**The Edgewater Reconsidered
March 18, 2010**

The Edgewater Reconsidered

The Edgewater as proposed has evolved well beyond a simple hotel addition to a complex that attempts to incorporate six independent profit centers, a 175 to 180-room luxury hotel, 9 to 14 semi-independent condominium residences, three (four include the dining pier) restaurants totaling 12,000 SF, a 12,000 SF meeting, banquet and convention facility, a 10,000 SF spa and fitness center and not less than 120 parking stalls for National Guardian Life

The Edgewater Reconsidered
 Lower Level 4 @ 1" = 50'
 March 18, 2010

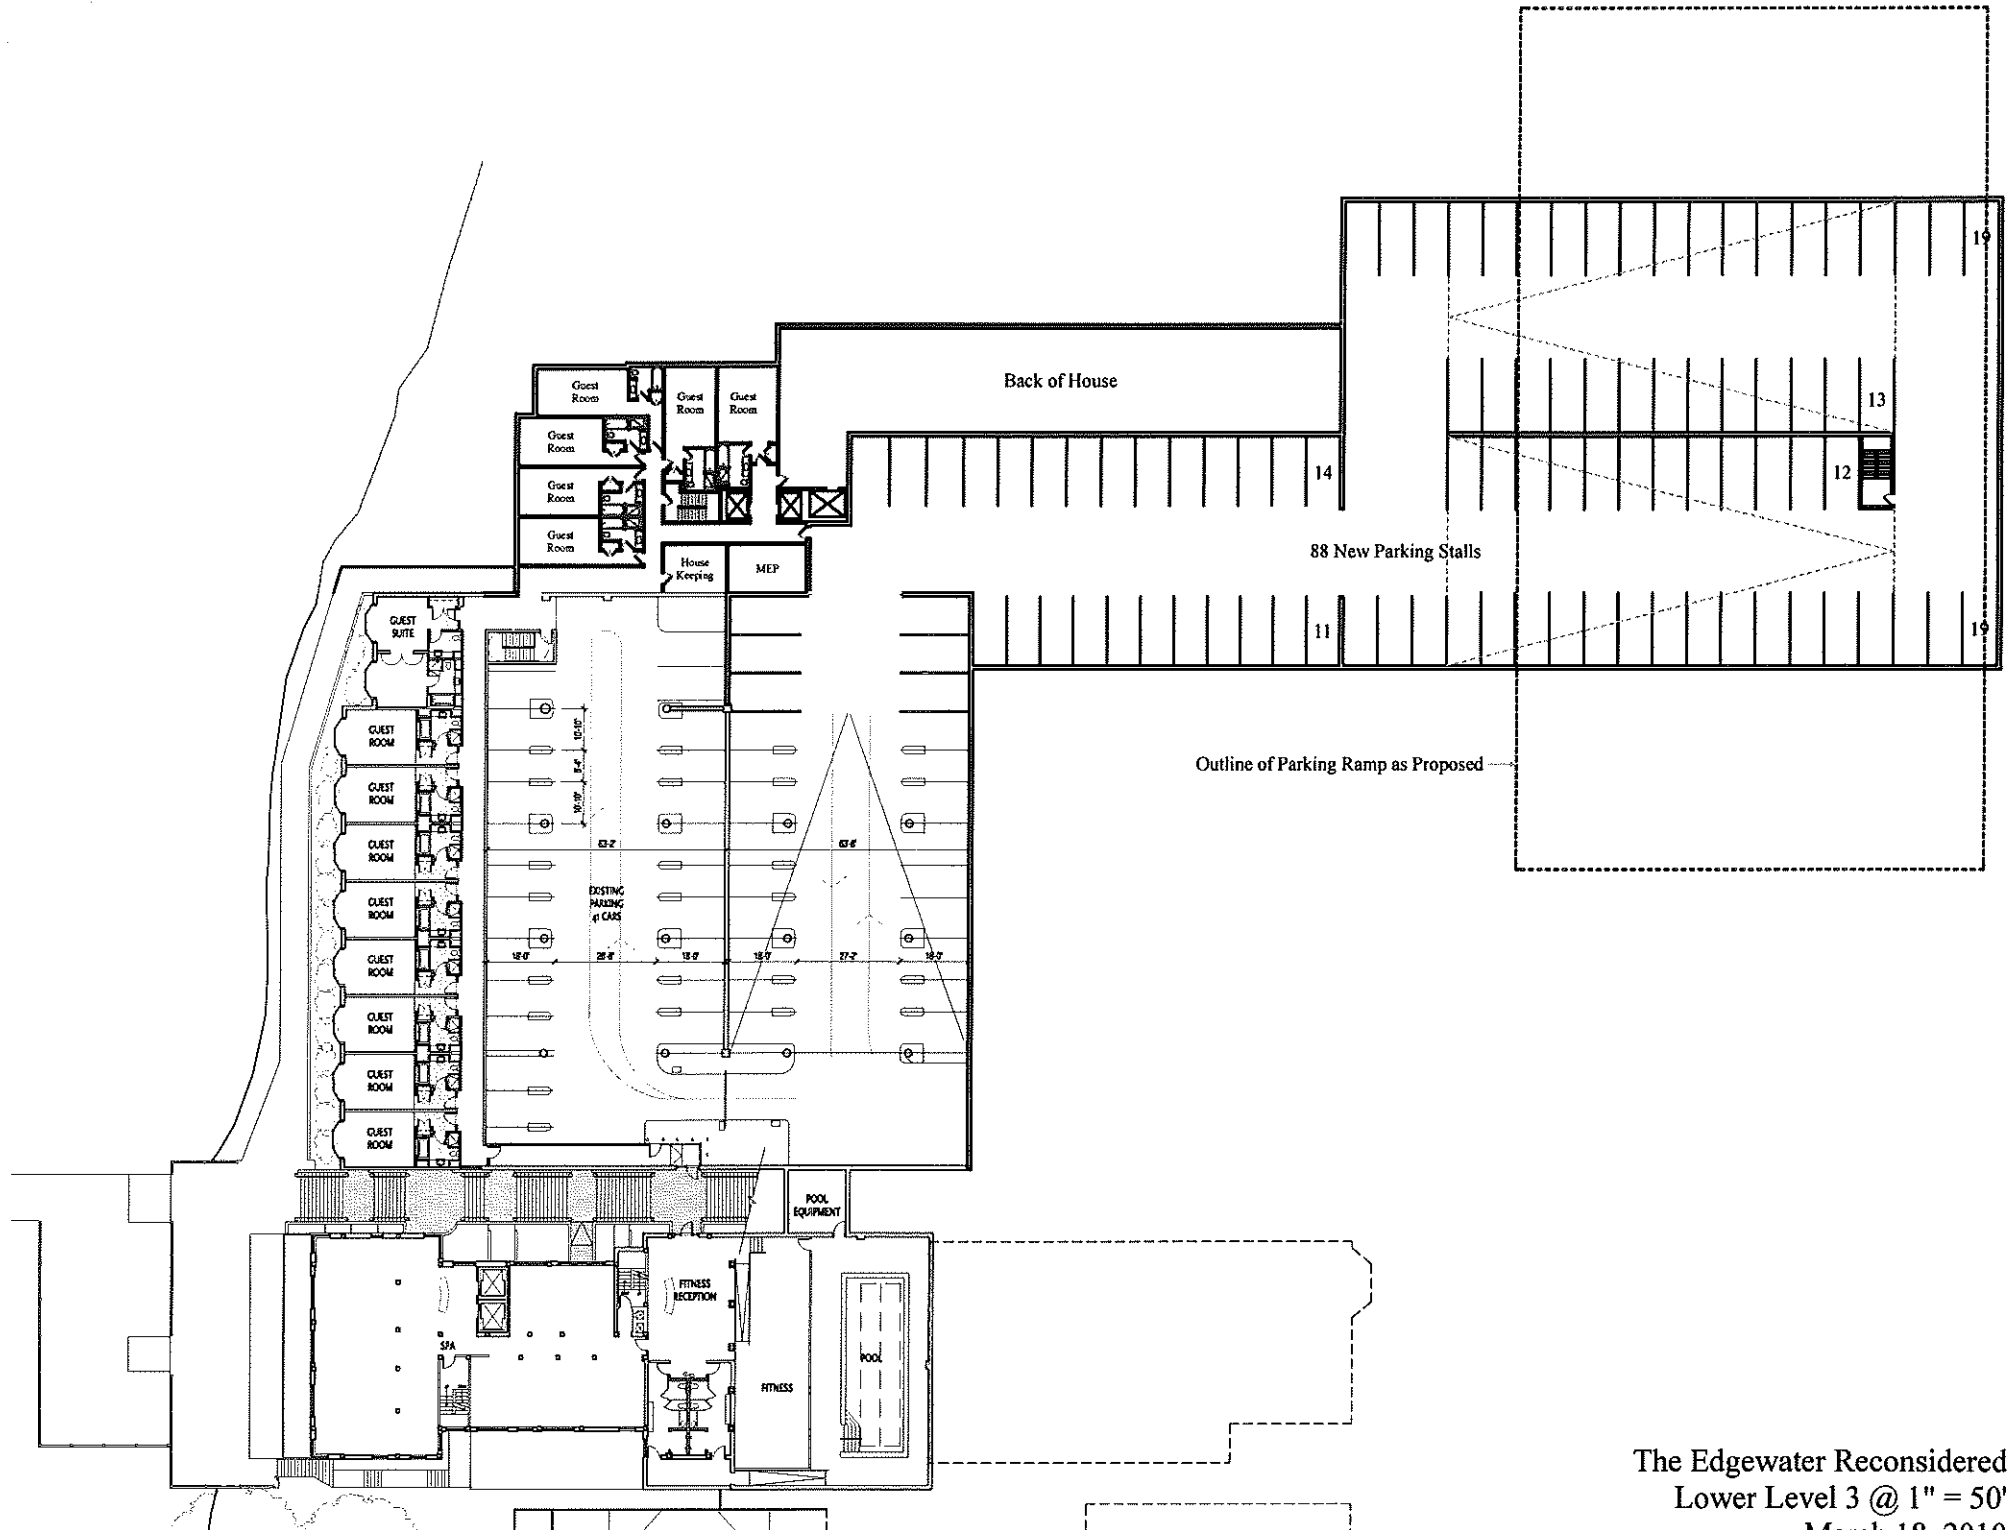
Existing Building:	
Lower Level 5	25
Lower Level 4	43
Lower Level 3	44
Lower Level 2	47
Sub Total	159
Under Proposed Building:	
Lower Level 5	26
Lower Level 4	26
Lower Level 3	25
Lower Level 2	25
Sub Total	102
Shared with National Guardian:	
Upper Level 3	63
Upper Level 2	60
Lower Level 1	63
Sub Total	186
Total Parking	
As Required	450+
As Proposed	355
As Reconsidered	447

The Edgewater Reconsidered
 Lower Level 3 @ 1" = 50'
 March 18, 2010

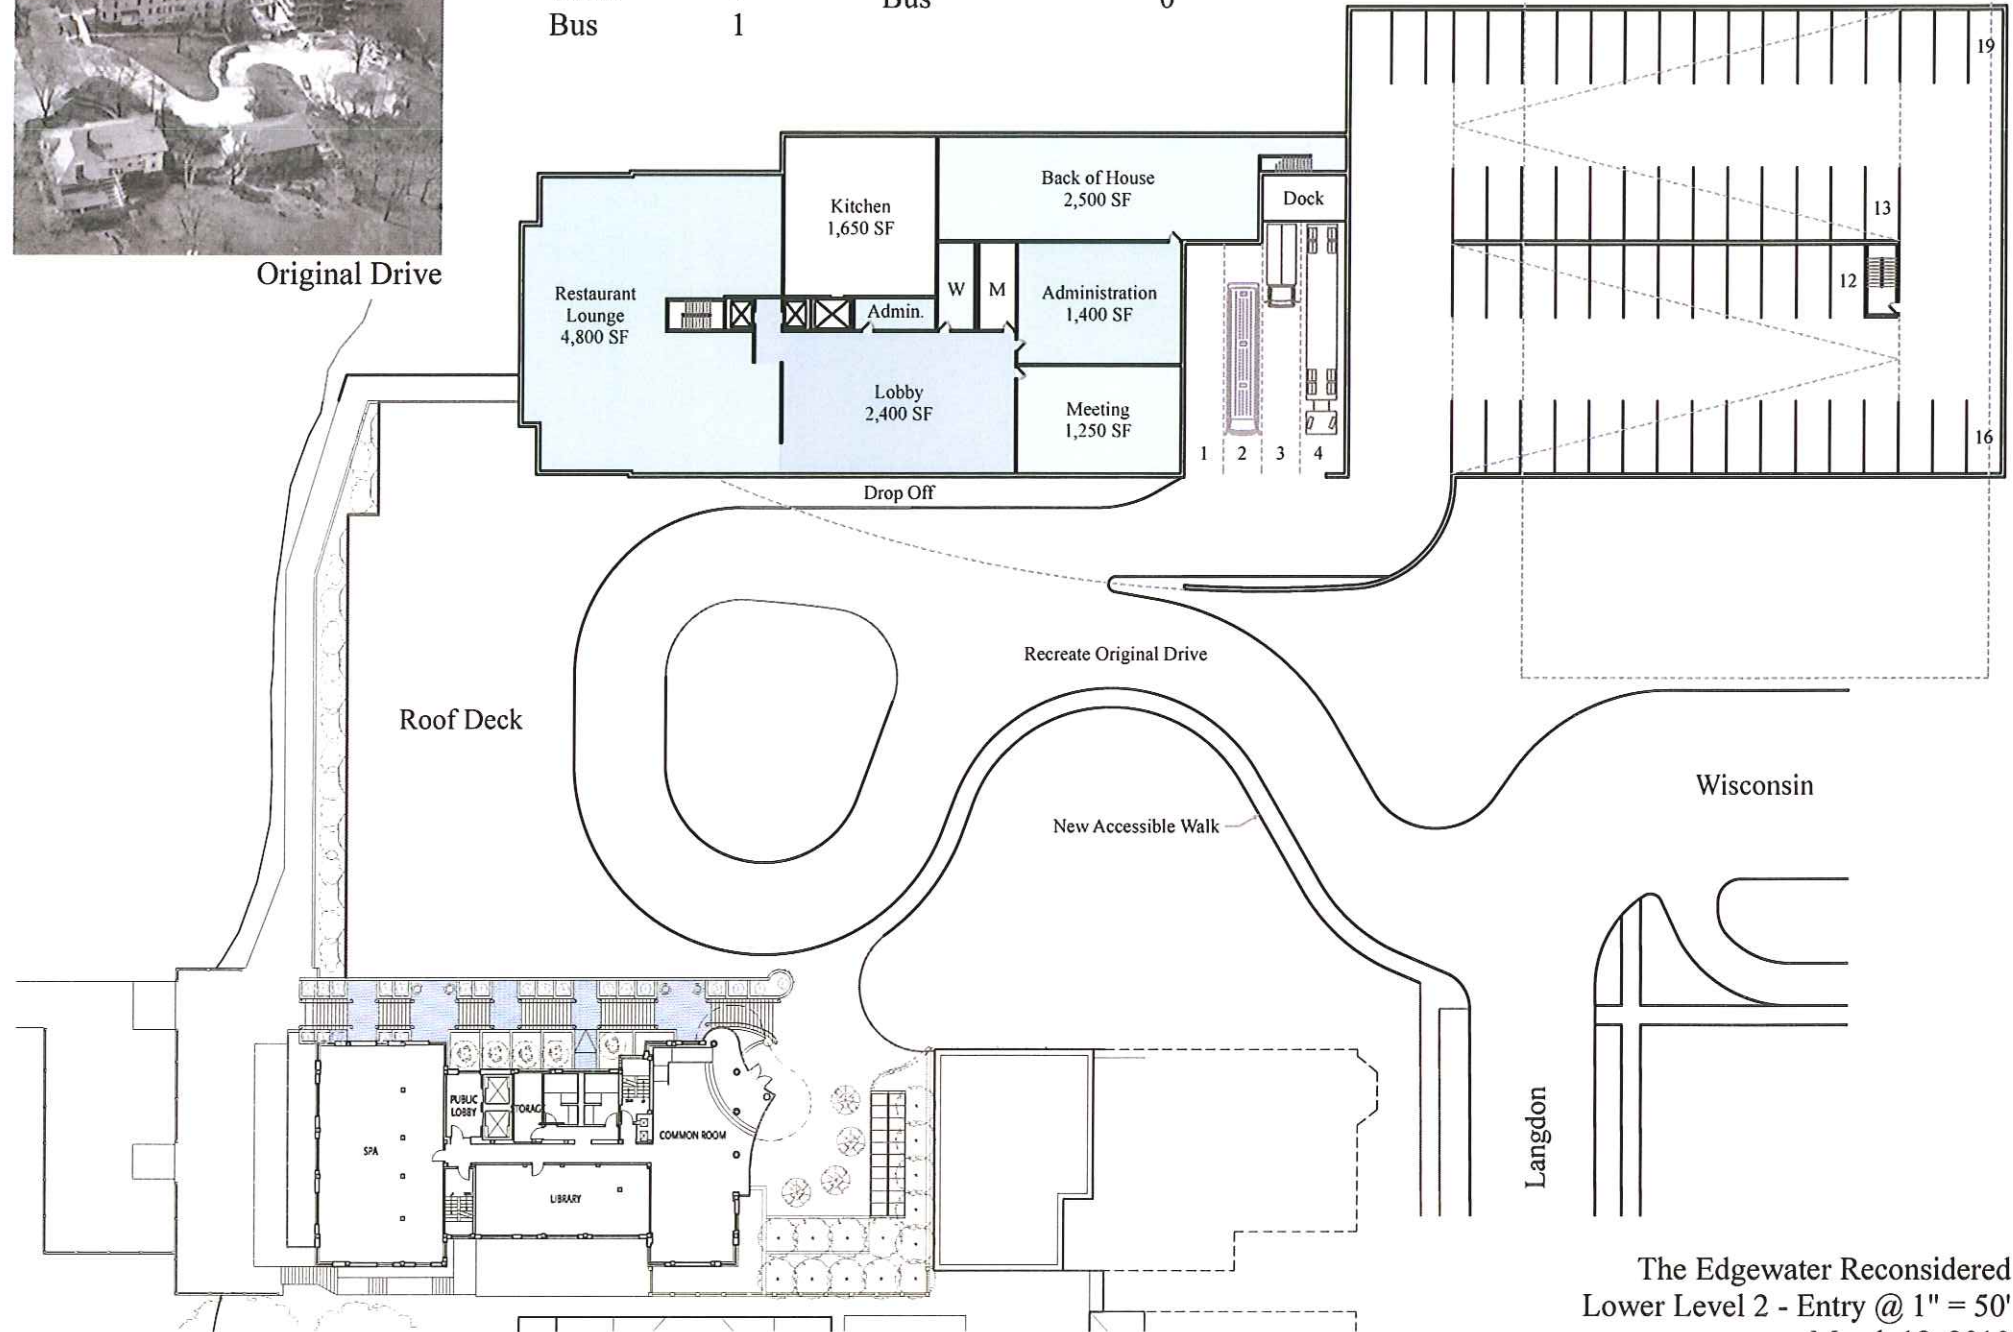
Loading Bus Berths:

As Reconsidered:

Semi-Trailer	1
Fixed Axel	1
Trash	1
Bus	1

As Proposed

Semi-Trailer	1
Fixed Axel & Trash	1 (Shared)
Bus	0

The Edgewater Reconsidered
 Typical Proposed & Reconsidered Floors Compared @ 1" = 25"
 March 18, 2010

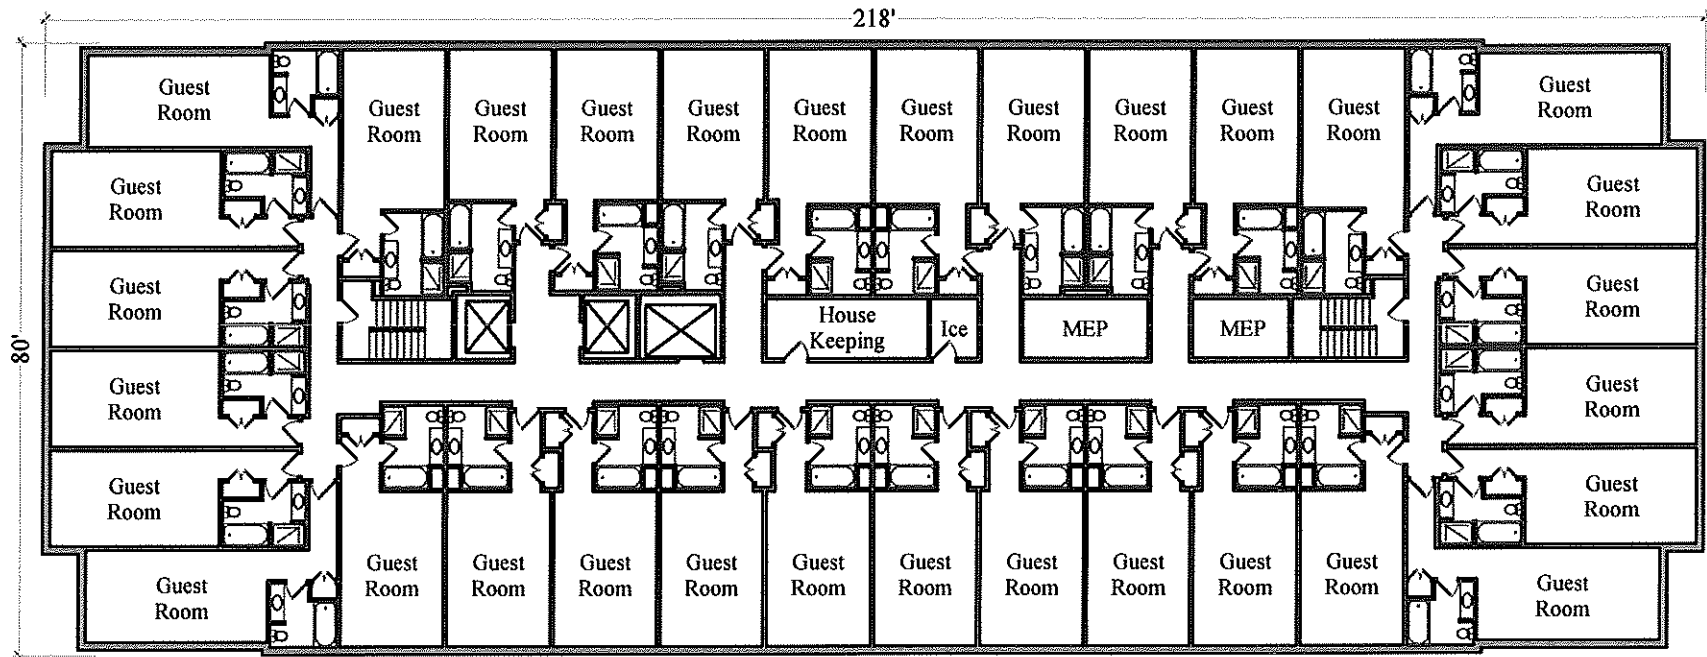
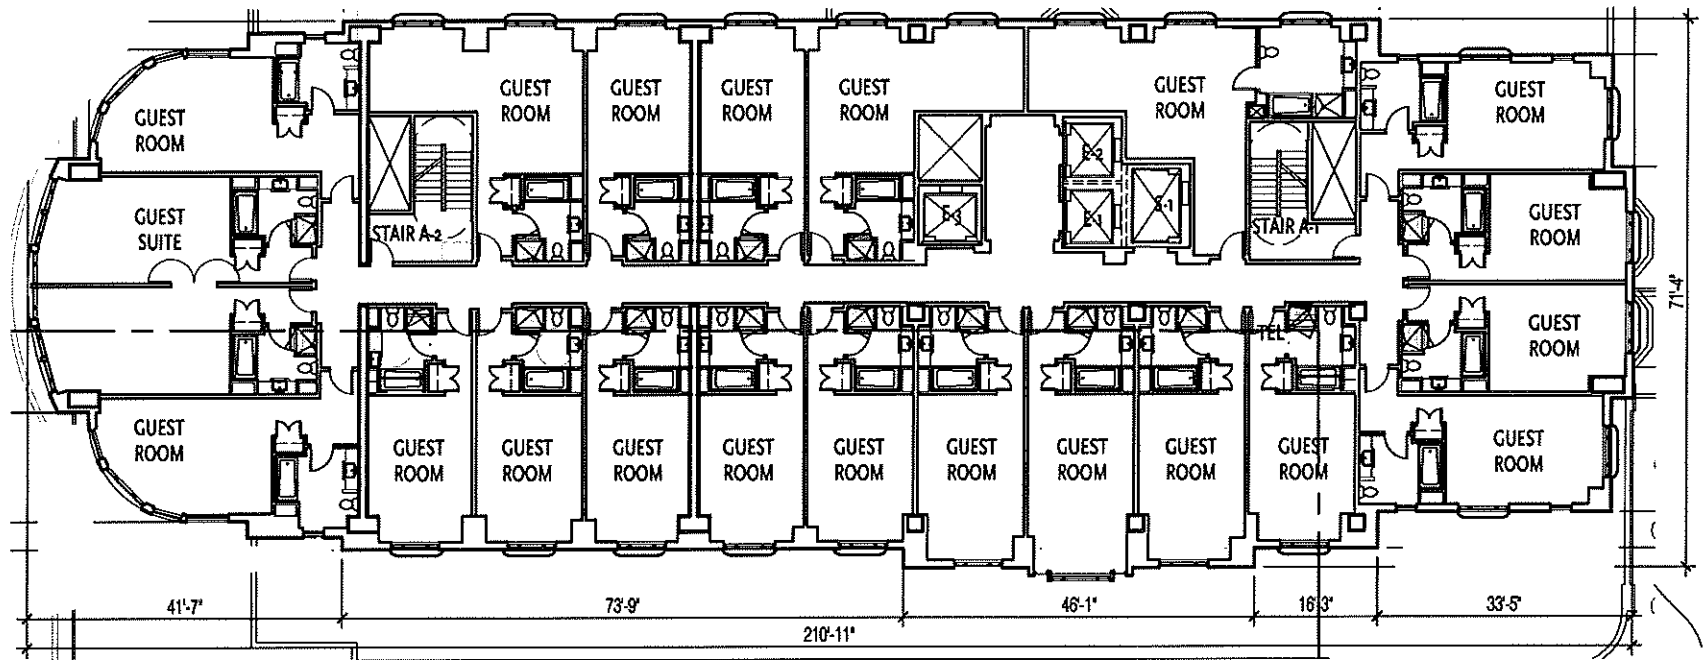
As Proposed 22 Keys, 13,715 GSF, 84.1% Efficient
 As Reconsidered: 32 Keys, 17,125 GSF, 86.6% Efficient (Housekeeping & Ice Missing)
